## Executive Director's Recommendation

Commission Meeting: September 6, 2012

#### **The Memorial to Victims of Ukrainian Manmade Famine of 1932-1933**

Preliminary and final approval of  
site development plans

Figure 6: Field of Wheat Concept Site Plan

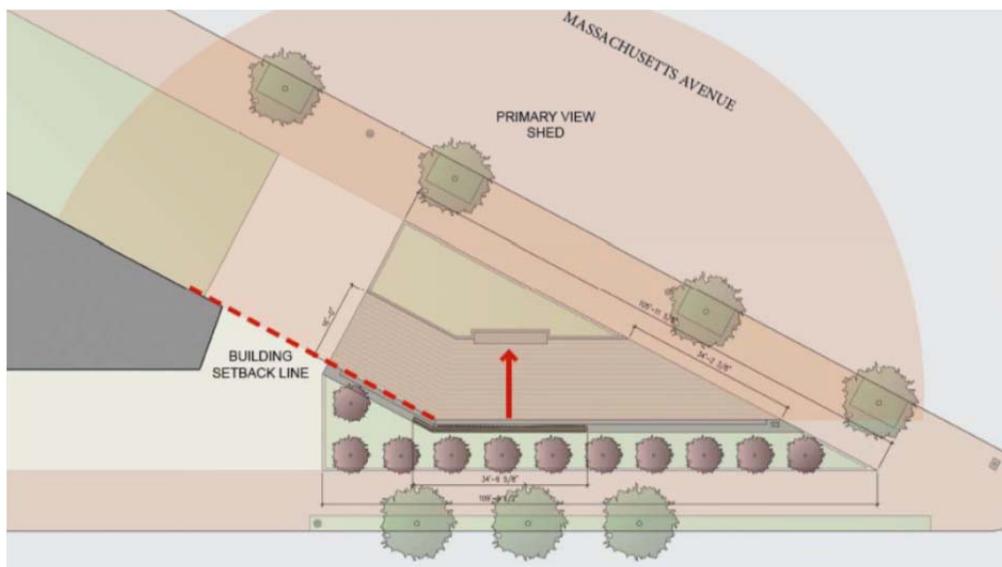
The Commission provided comments on the informational presentation. Most comments pertained to the NPS preferred alternative, the Field of Wheat concept. Concerns were raised regarding the sculptural element's appearance along F Street, NW in terms of height and design. At that time, the design of the back of the sculptural element was not determined and created a blank wall along F Street, NW. Regarding the height of the sculpture, concern was raised about having the appearance of a wall, which may create an uninviting experience along F Street, NW. Also, the proposed tall cylindrical trees between the sculpture element and F Street, NW could also create a large vegetation wall that may overwhelm pedestrians. The applicant and the design team took these concerns into consideration as they developed the design further.

Figure 10: Field of Wheat Final Site Plans

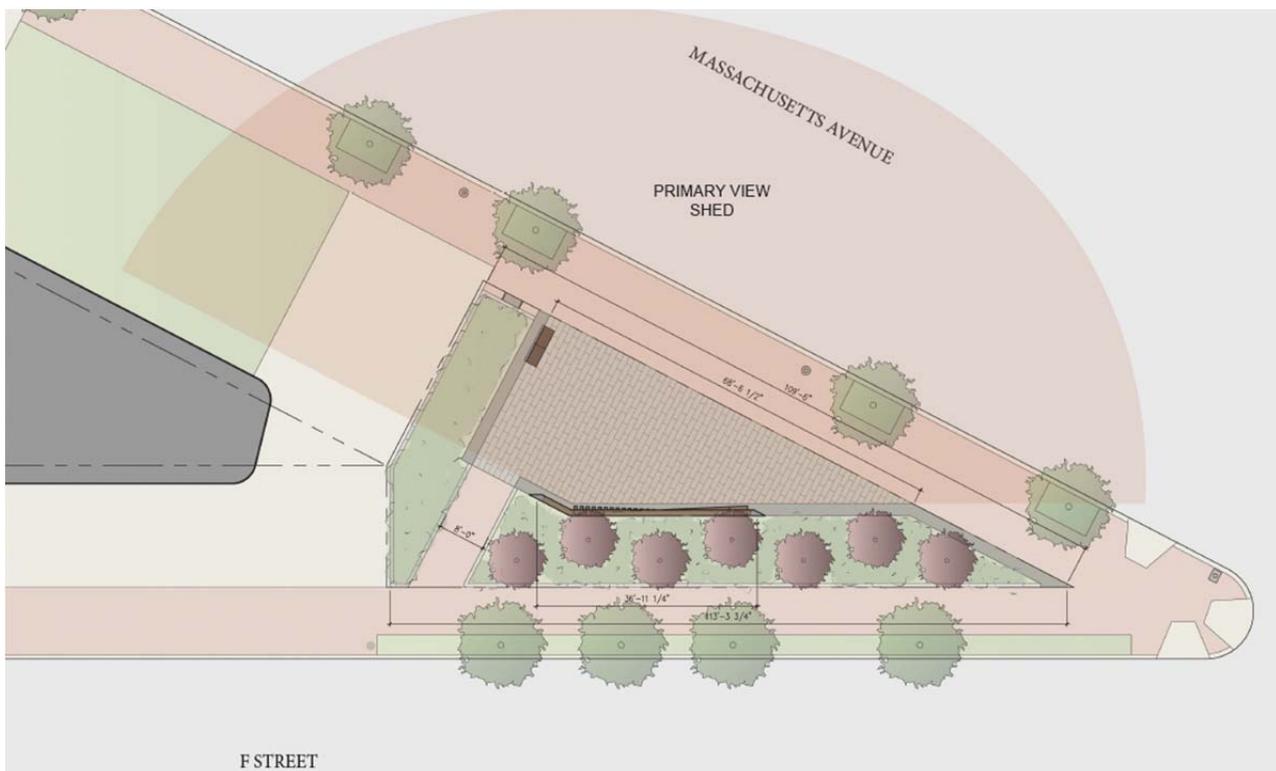
The proposed memorial would replace grass panel, flagpole, and two small trees with a plaza, vegetation, and a sculpture element. The proposed design improves an underused U.S. reservation and creates a space that can be used and enjoyed by the public.

The site includes two planting beds that totally to approximately 1,400 square feet of planting or about forty-five percent of the site. The intent of this design guideline was to ensure that the site, which is grass panel today, did not become entirely hardscape. Staff finds the memorial incorporates a landscape plan that will improve the site with trees and shrubbery.

The linear sculpture has a bent panel that is approximately aligned with the Massachusetts Avenue build-to line, which marks the end of the right-of-way, and the northern façade of the Childs Restaurant building. Additionally, the placement of the sculpture and the landscape design allow views between the site's apex and the entrance to the Childs Restaurant building.

A portion of the sculpture would be approximately aligned with the Massachusetts Avenue, NW orientation and the Childs Restaurant building. The site is accessible along Massachusetts Avenue, NW and F Street, NW. Since the informational presentation, the NPS has added a pathway from the memorial plaza area to F Street, NW, to provide the connection between F Street, NW, and the memorial.

Figure 14: F Street, NW Rendering

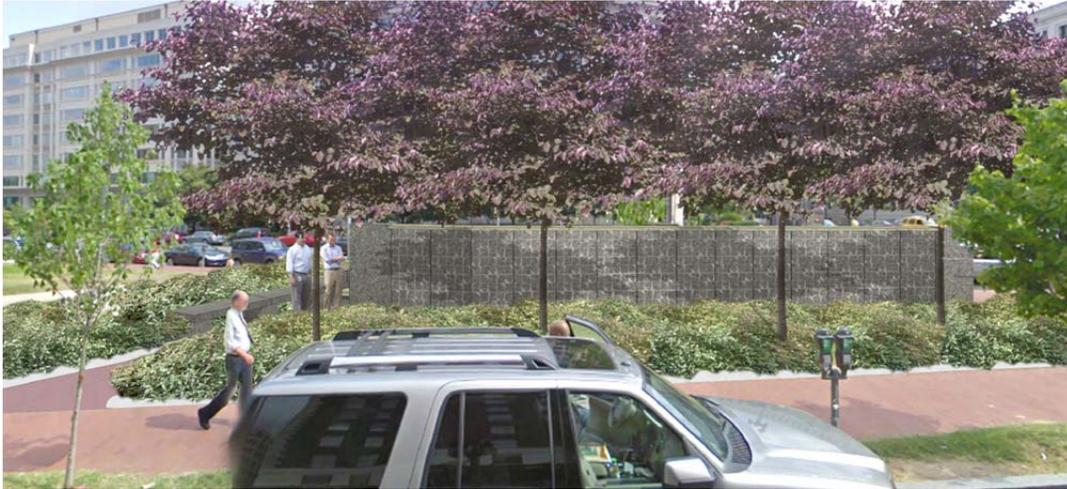
The main concern raised by the Commission at the December 2011 informational presentation was the experience along F Street, NW in that the memorial sculpture element gave the appearance of a blank wall close to the F Street, NW sidewalk. Since the December meeting, the applicant has had multiple consultation meetings with NCPC, CFA, and DC SHPO staffs to discuss options on how to make the sculpture element less overpowering on F Street, NW. As a result of these discussions, the NPS:

- Added a pattern to the back of the memorial to provide visual interest and texture. The Pattern was extrapolated from textile patterns in Ukraine in the 1930's.

- Moved the sculpture northward towards Massachusetts Avenue, NW. This created a larger planting bed between the sidewalk and the sculpture element.
- Changed the landscaping in the planter bed; the tall beech trees that may have created a vegetative wall appearance were replaced with red bud trees that provide views to the memorial site and allow for understory plantings.

The renderings below show the view of Reservation 78 looking both east and west along F Street, NW. The renderings show that the new proposed location of the wall is not overpowering to pedestrians on F Street, NW and the memorial provides an adequate landscaping area that enhances the pedestrians' experience on F Street, NW by providing landscape for visual interest and shade on a street that lacks trees.
